November 5, 2024

On behalf of the Cannington Horticultural Society (CHS), I wish to thank you for the opportunity to comment on the 2024 MacLeod Park Redesign Concepts. Our consideration of this project was greatly enhanced by attending the Open House held on October 24. We appreciated the helpful and open discussions held with the Township of Brock representatives and their detailed responses to our many questions. We are providing the following proposals for the MacLeod Park Redesign:

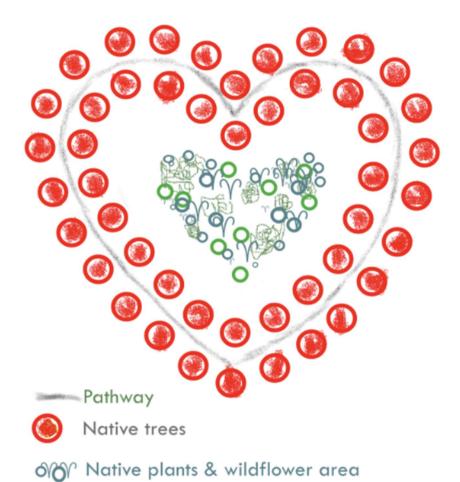
- We are also requesting for you to add the existing CHS gardens to the Concept Design visuals, consistent with the other existing park aspects that will be retained moving forward. We have included an edited copy of both Concepts as Attachments 2 and 3

with the gardens added to facilitate this request. The garden images are intended to be the same in both, despite the challenges in drawing each by hand.
